Mowbray, North Horsham, West Sussex (Phase 2)

Technical Note

RMA3

Table 1: Response to WSCC LLFA comments

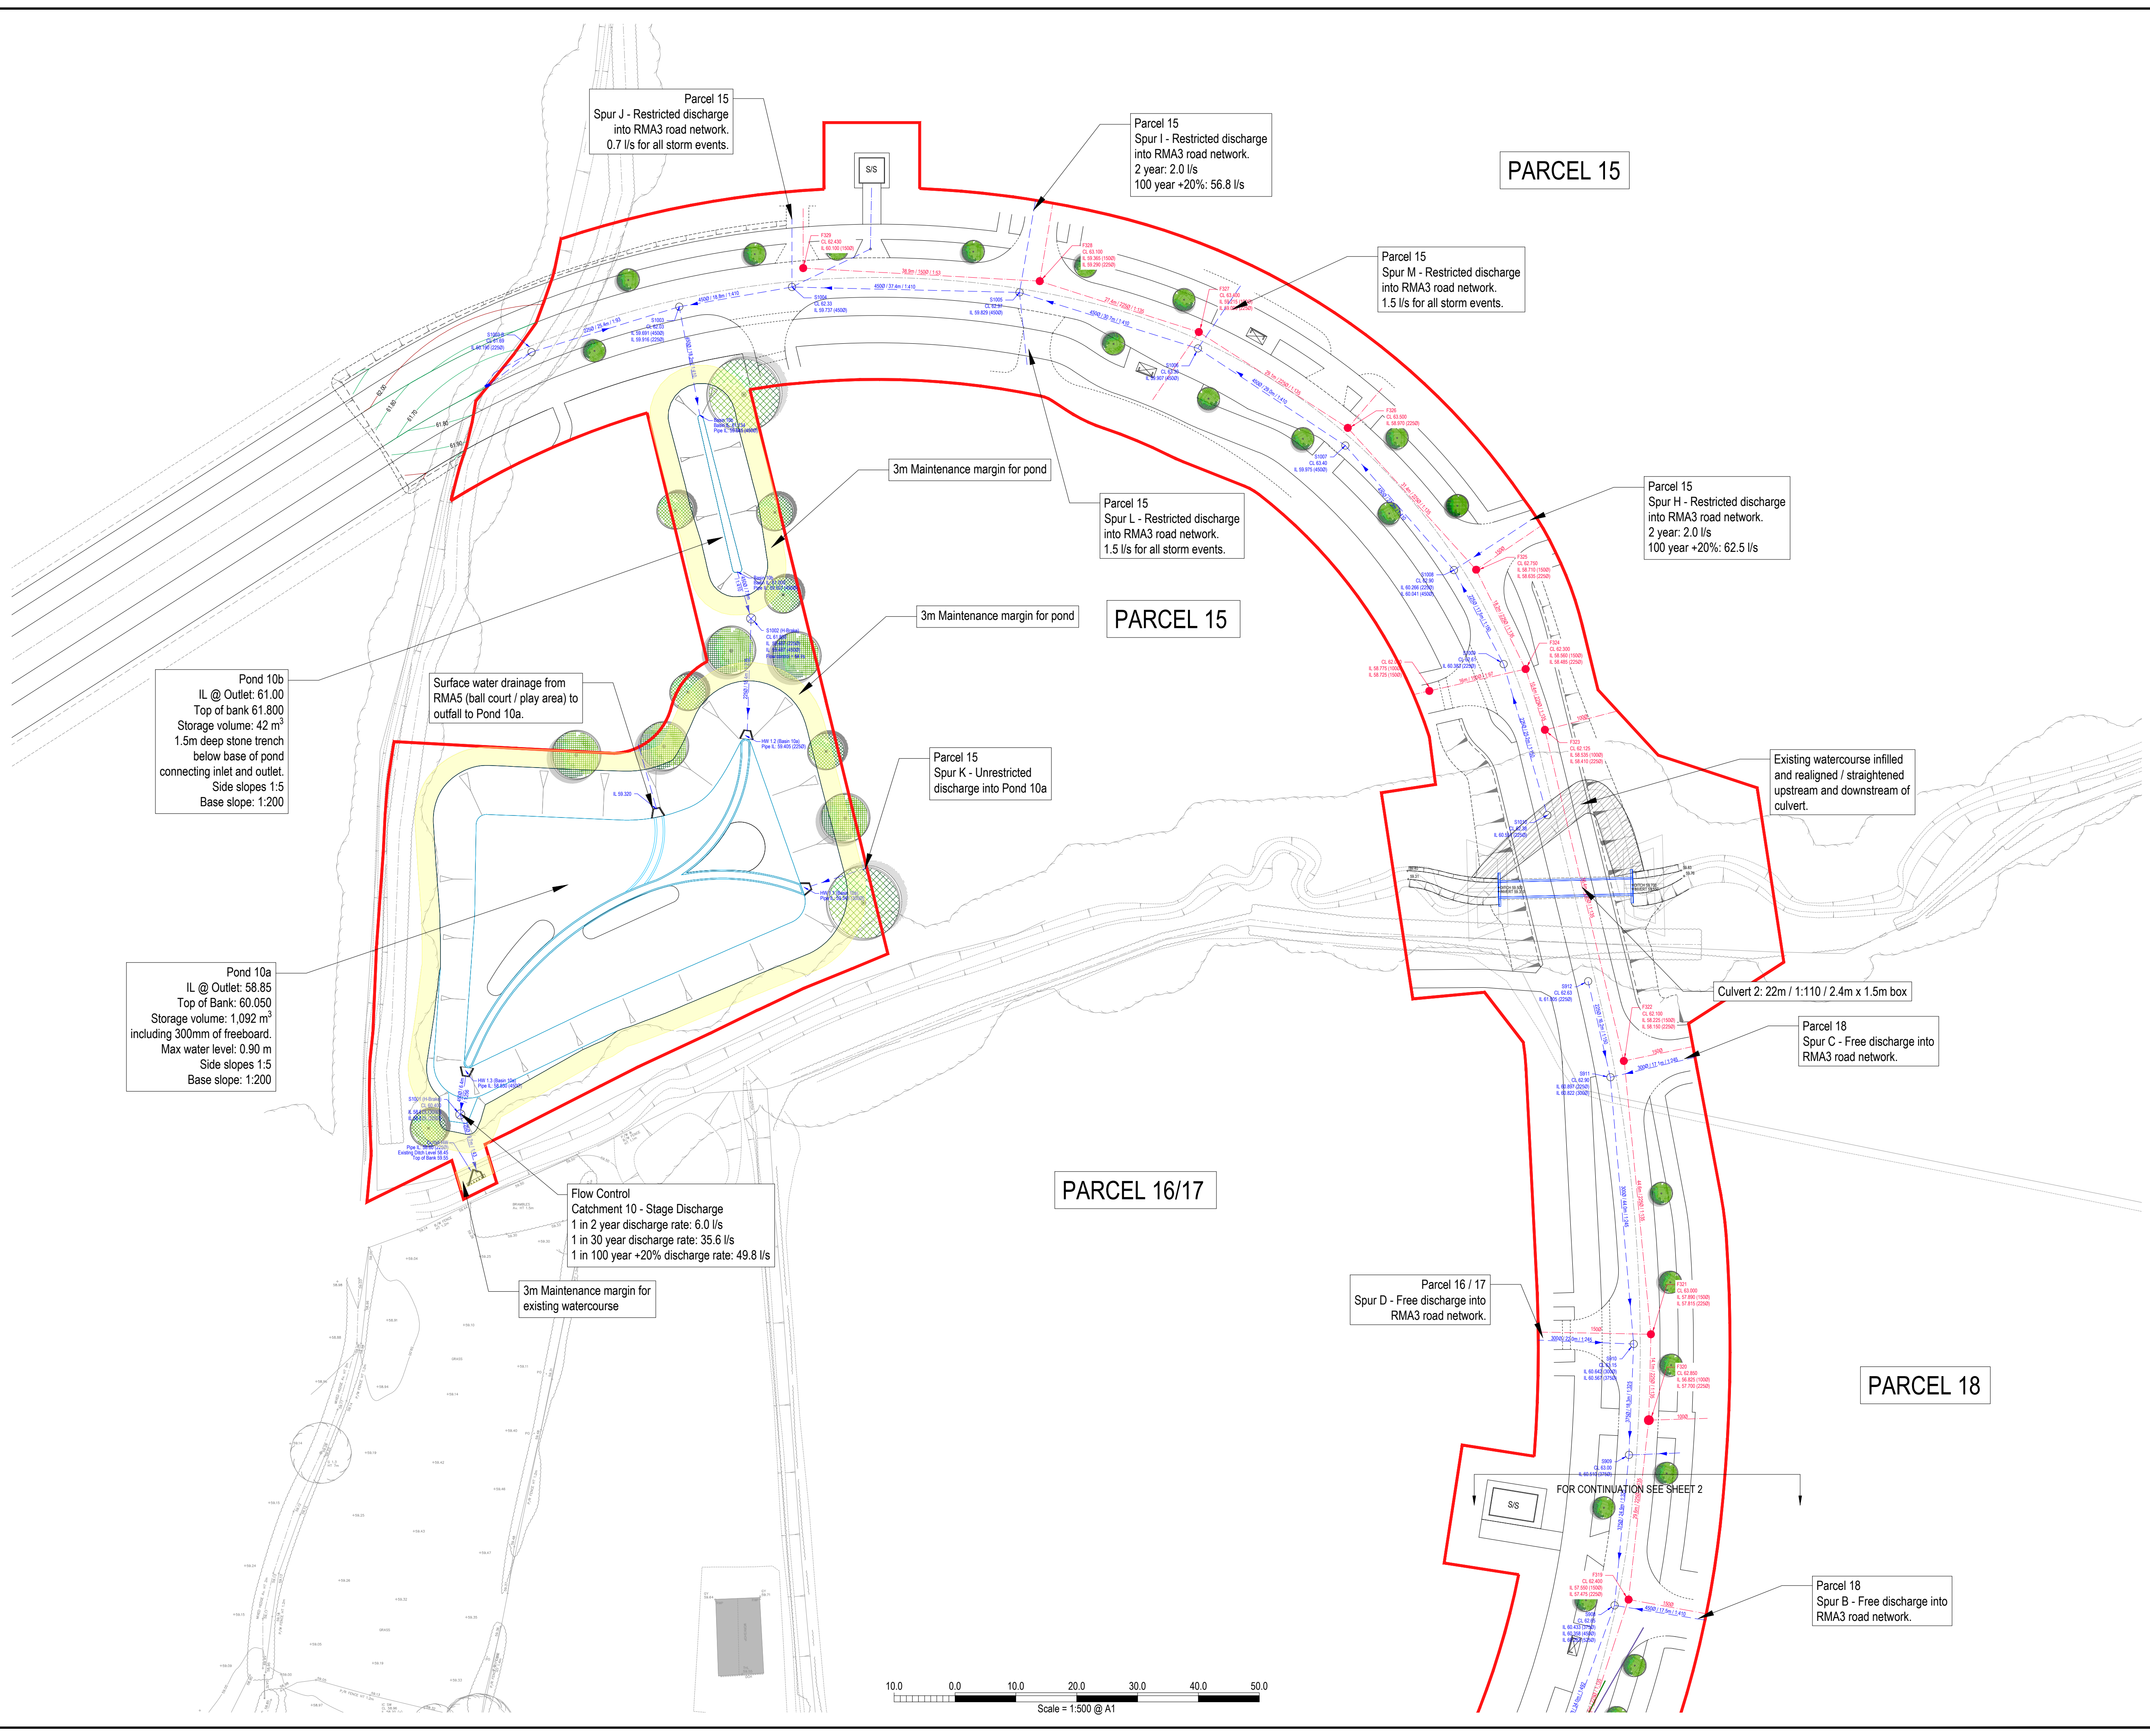
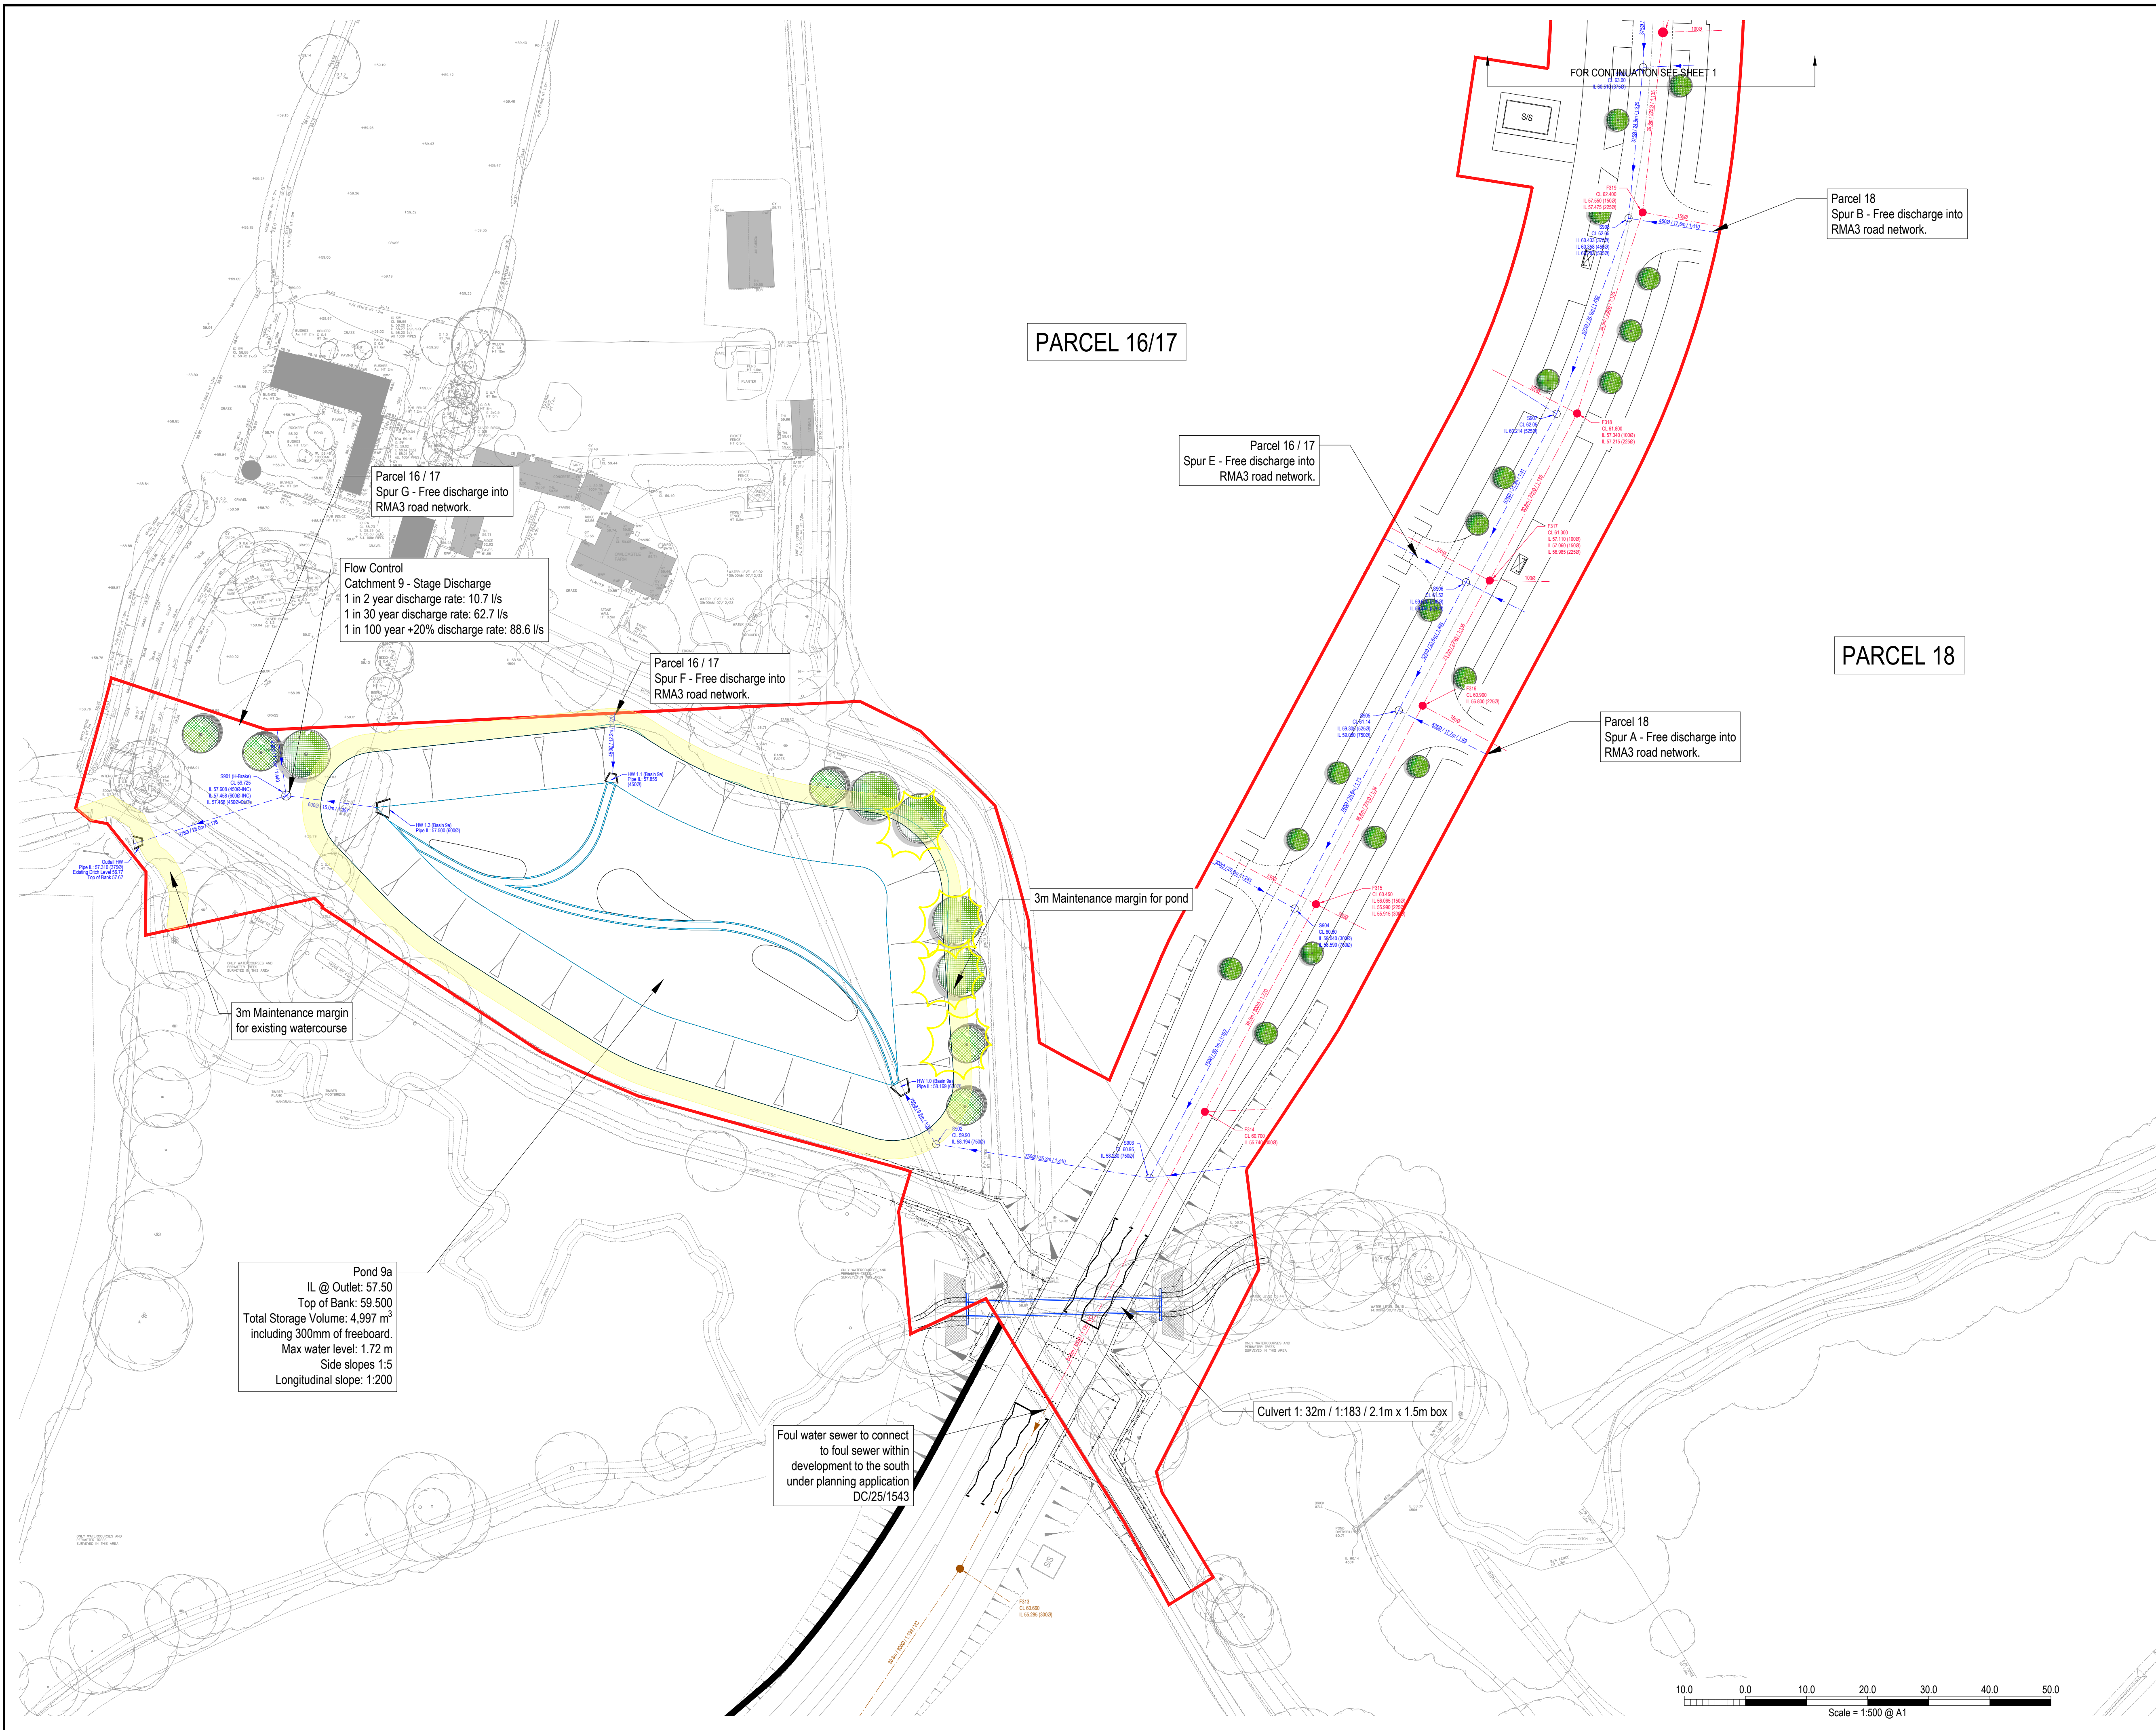
- There are some clashes between the landscaping plans and basins, which could affect maintenance.
- The easement for culvert 2 needs to be added, to ensure there is maintenance access.

4	The easement for culvert 2 needs to be added, to ensure there is maintenance access	Both Culvert 1 and Culvert 2 will be adopted by WSCC Highways under a S.38 Agreement. The detailed design of the culverts will be dictated by the Highway Agreements Officer in WSCC Development Control and the WSCC Highway Structures team, which will ensure access for maintenance is provided to WSCC Highways.

P3	Updated tree locations and landscaping.	06/08/2026	SLS	CS
P2	Updated to client comment.	08/04/2026	SLS	CS
P1	First Issue	25/03/2026	SLS	CS
Rev.	Description	Date	By	Chkd
